**U.S. NUCLEAR REGULATORY COMMISSION
Office of Nuclear Material Safety and Safeguards
Spent Fuel Project Office**

**CONFIRMATORY ACTION LETTER 97-7-001
TECHNICAL EVALUATION**

Docket No: 72-1007

Certificate Holder: Sierra Nuclear Corporation
One Victor Square
Scotts Valley, CA 95066

Figure A1

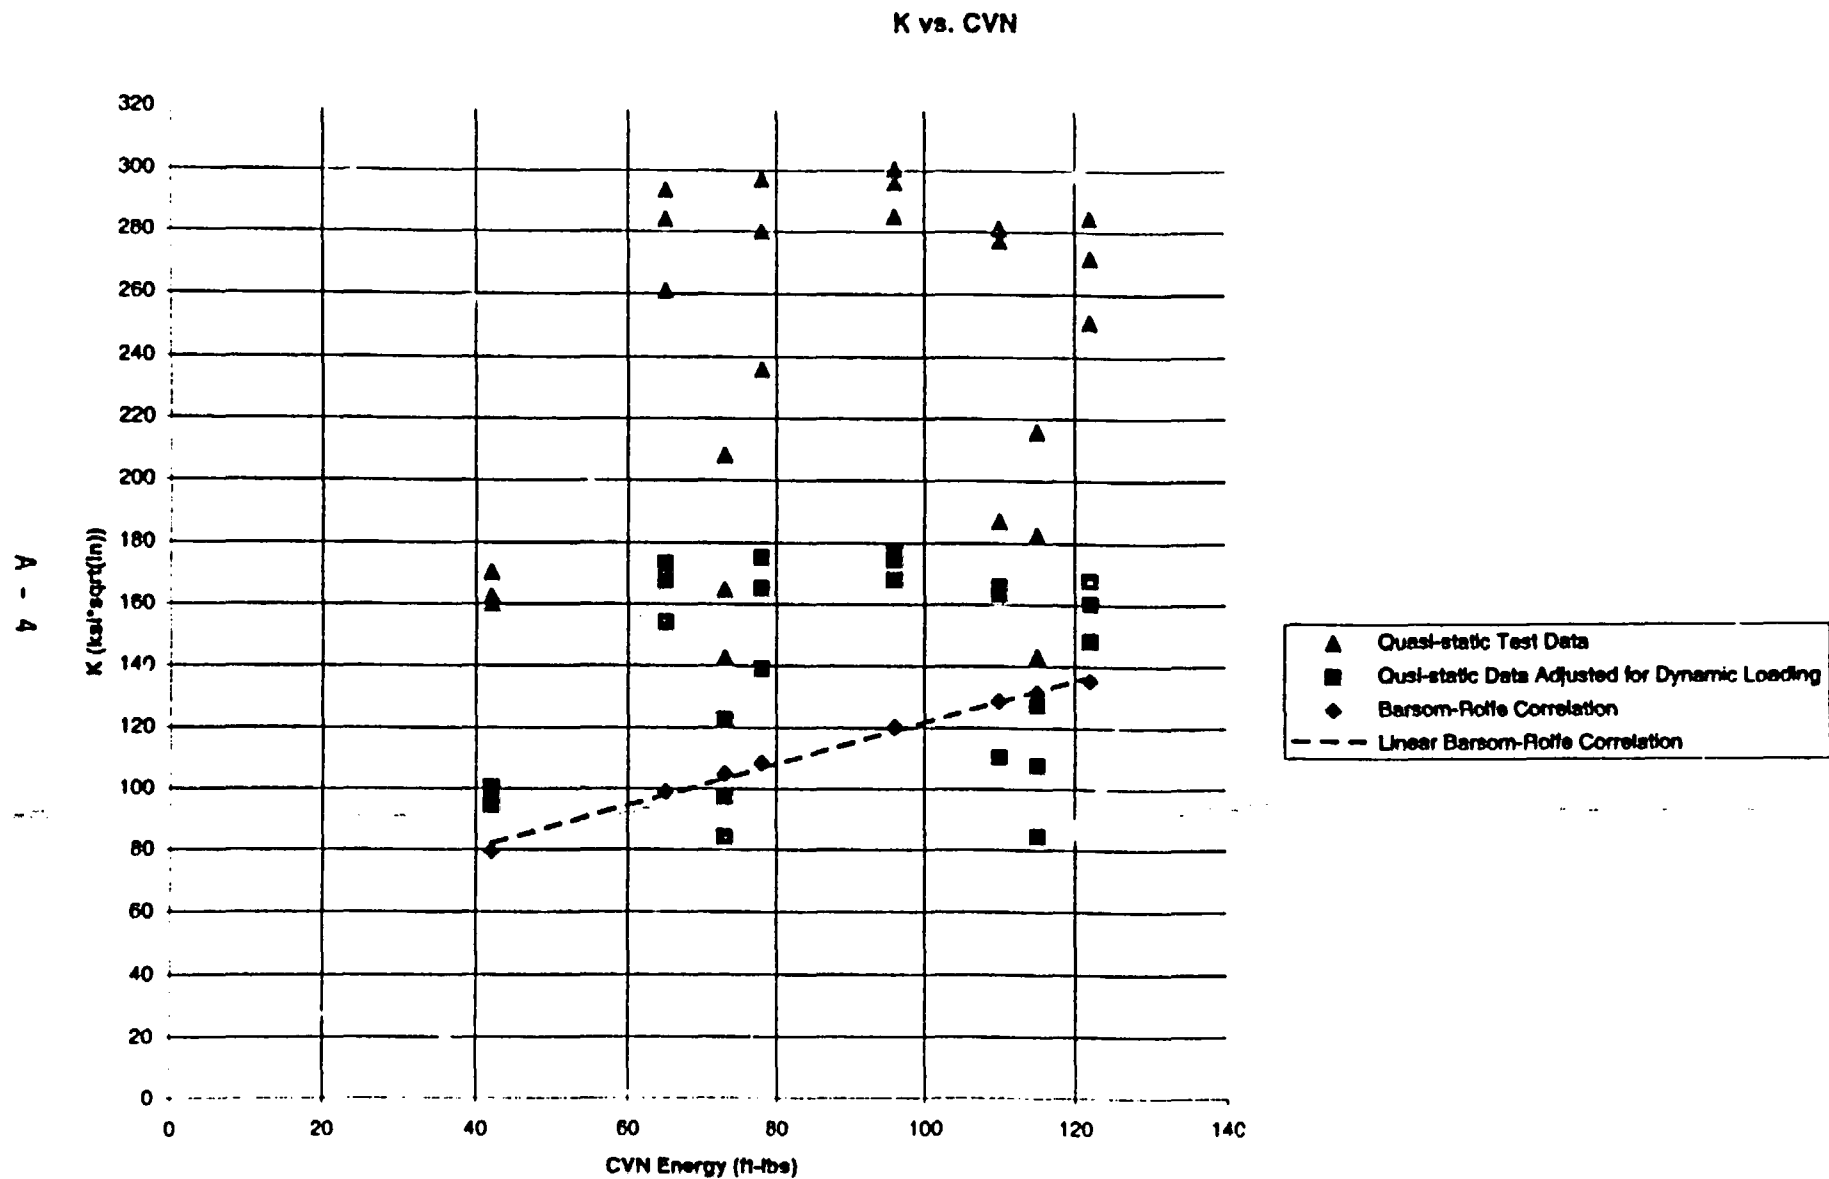
The staff plotted the data for fracture toughness and CVN provided by the Owners Group (Figure A1). The staff did not observe any relationship between K_{IC} and CVN in the data presented and concluded that the Barsom-Rolfe correlation for the MSB material was inappropriate. This staff position was documented in the May 21, 1998, letter from NRC to SNC.

In its independent evaluation, the NRC staff considered fracture toughness data generated by both the Owners Group and NSWC and used the following approach to arrive at a limiting fracture toughness of 53 ksi $\sqrt{\text{in}}$ for a temperature of 0°F:

- (3) A lower bound for the adjusted data set was established at 75 ksi $\sqrt{\text{in}}$. A lower bound fracture toughness value can be established calculating the mean of the adjusted values and reducing the mean of the calculated dynamic data by twice the standard deviation.
- (4) This lower bound of the data set was then reduced by the ASME Section XI safety factor for the faulted condition ($\sqrt{2}$) resulting in the lower bound fracture toughness of 53 ksi $\sqrt{\text{in}}$ at 0°F .

Figure B1

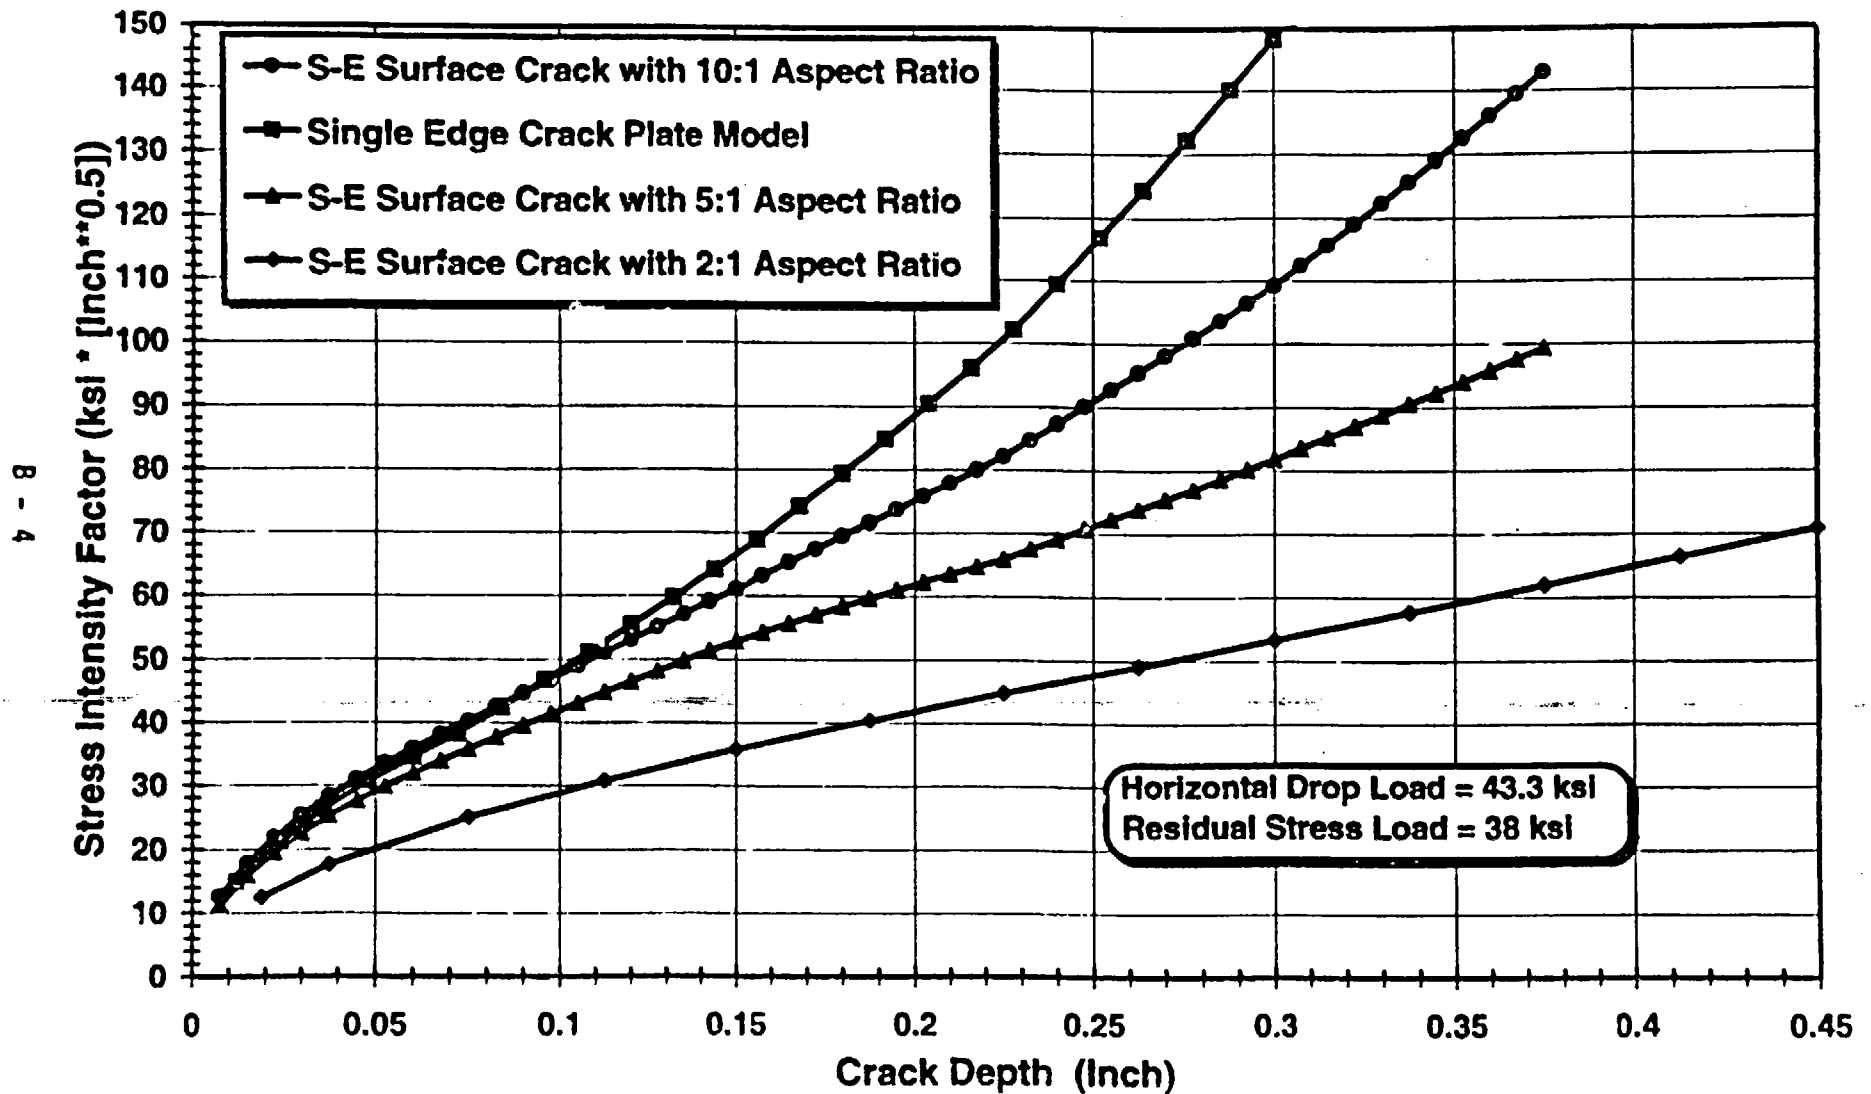
Figure B1 shows the maximum stress intensity factors (K_I) for the semi-elliptical cracks with aspect ratios, a/c , of 0.5, 0.2, 0.1 and 0 SECP, as a function of the crack depth. It can be seen that as the aspect ratio, a/c , value decreases from 0.5 to 0, the crack driving force (K_I) values increase with the SECP (i.e., for $a/c = 0$) being the highest value for any given crack depth.

Figure B2

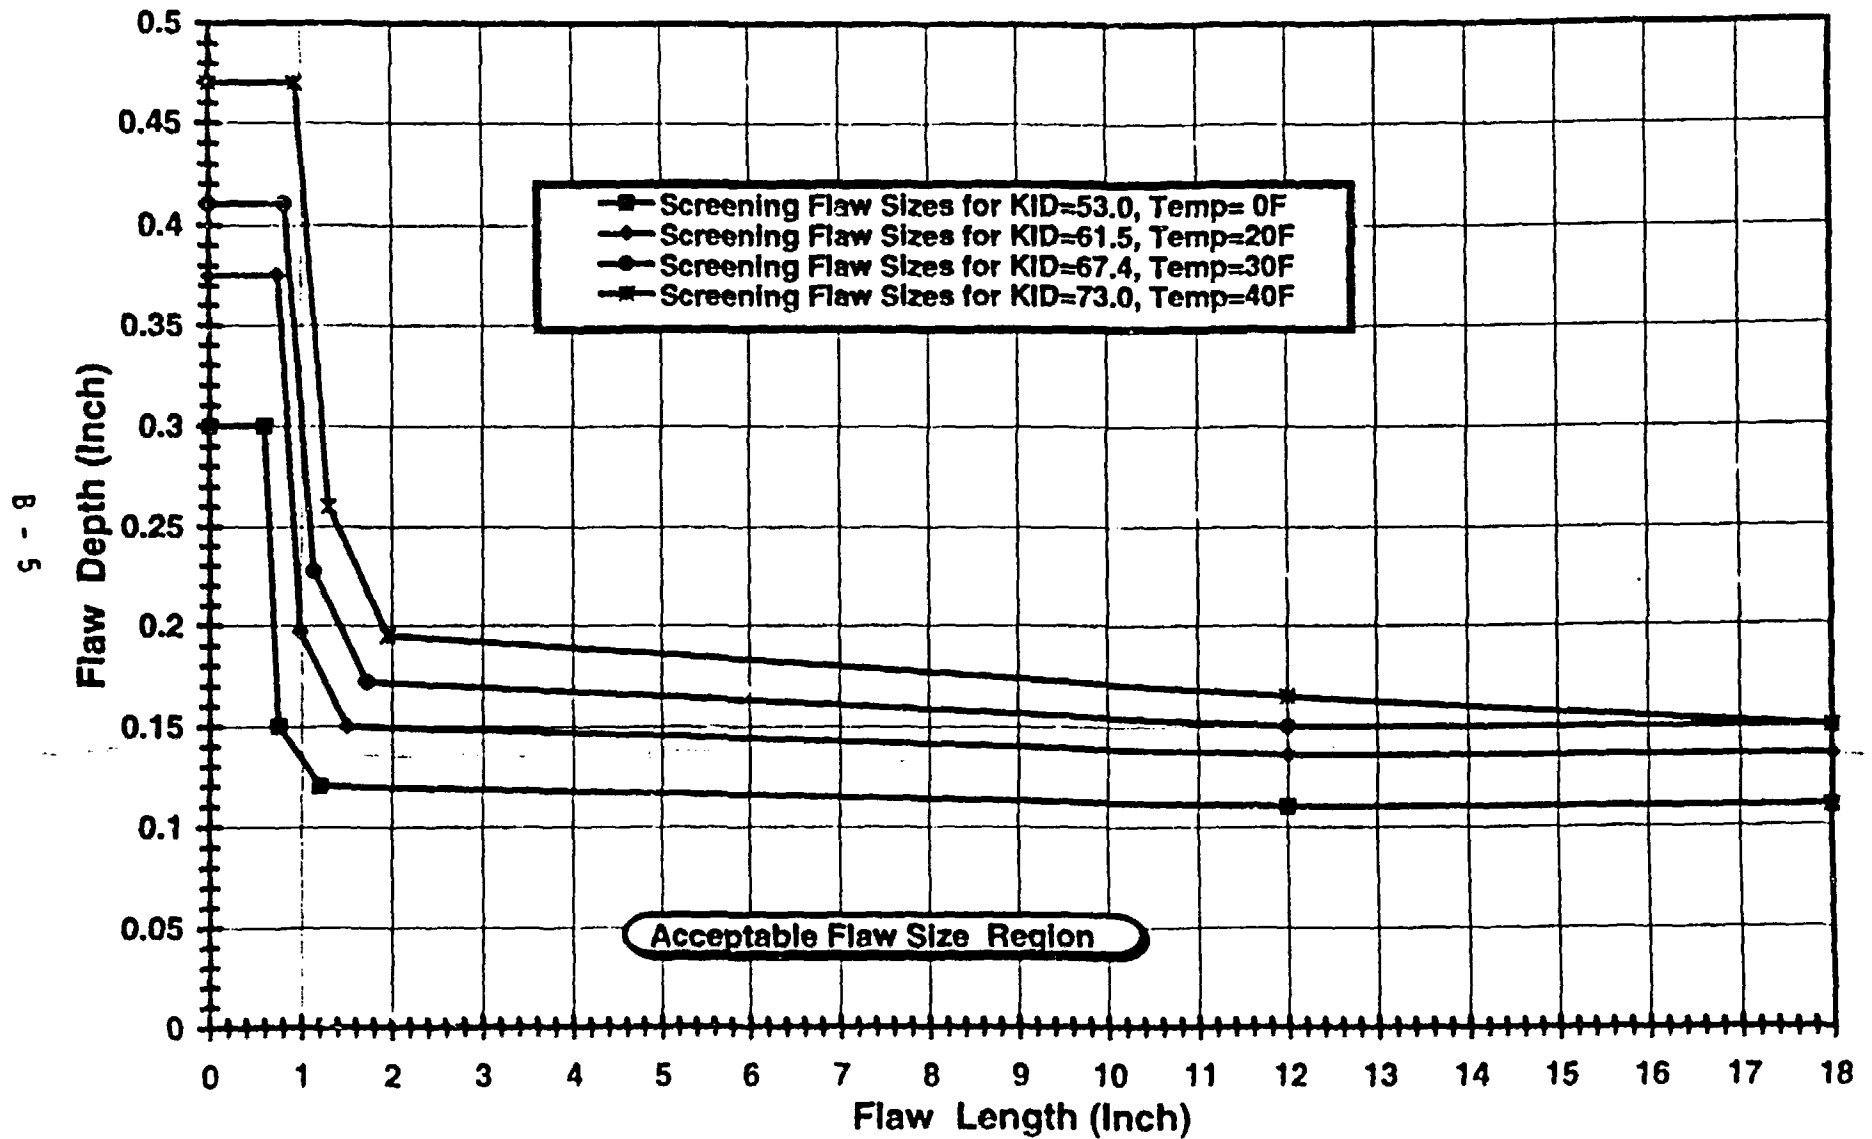
Flaw screening criteria to prevent cleavage crack propagation were determined on the basis of bounding estimates of dynamic fracture toughness (K_{ID}) values at assumed minimum closure weld service temperatures, as shown in Appendix A, Table A1. The flaw screening criteria (depths and surface lengths) criteria for semi-elliptical surface-breaking flaws are shown in Figure B2. For flaw lengths that are 18 inches or less (i.e., about 10% of the MSB shell circumference), the primary stress limits of NB-3000 are not exceeded, per Paragraph IWB-3610 (d) (2) of Section XI to the ASME Code (1989).
